Report to the Future Melbourne (Planning) Committee

Ministerial Planning Referral: TPMR-2014-35/B 7-23 Spencer Street, Docklands

DELEGATE REPORT MINISTERIAL PLANNING REFERRAL

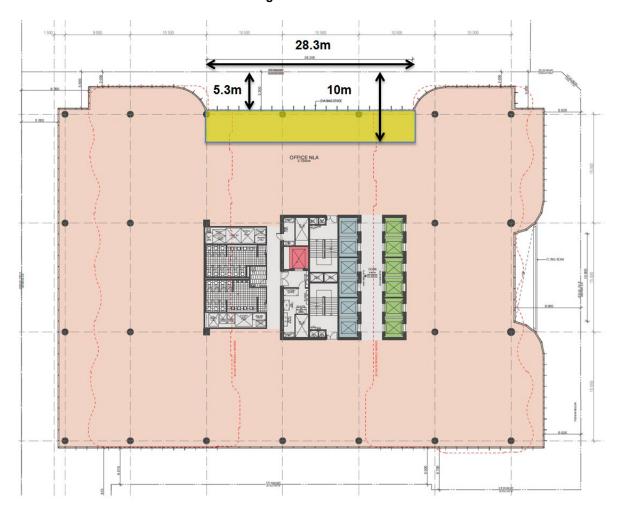
The without prejudice plans propose a street wall height of 33.13 metres with the office tower setback a minimum of 2 metres from Siddeley Street, 5.06 metres from Spencer Street 5.02 metres from the southern boundary and 9.25 metres from Little Dock Lane.

The amended street wall at 33.13 metres is considered an appropriate response as it defines the street corners and both Spencer Street and Siddeley Street are wide streets which can accommodate higher street walls.

27. Shadow Diagram 1pm and 2 pm 22 June. Source: Fender Katsalidis Architects Pty Ltd dated 26 June 2020

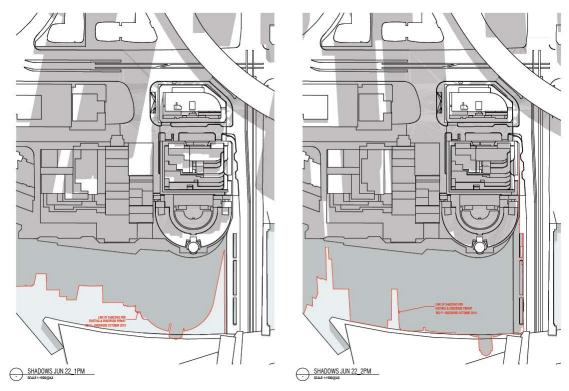
Table 2 of Schedule 10 lists those public places which must not be overshadowed on specific dates and times unless the overshadowing will not unreasonably prejudice the amenity of the space. Although this does not specifically relate to this amended application, Batman Park is included in Schedule 10 for the hours between 11am and 2pm from 22 April to 22 September. The shadow diagrams provided demonstrate that the amended proposal will not overshadow Batman Park during the specified hours and times of the year.
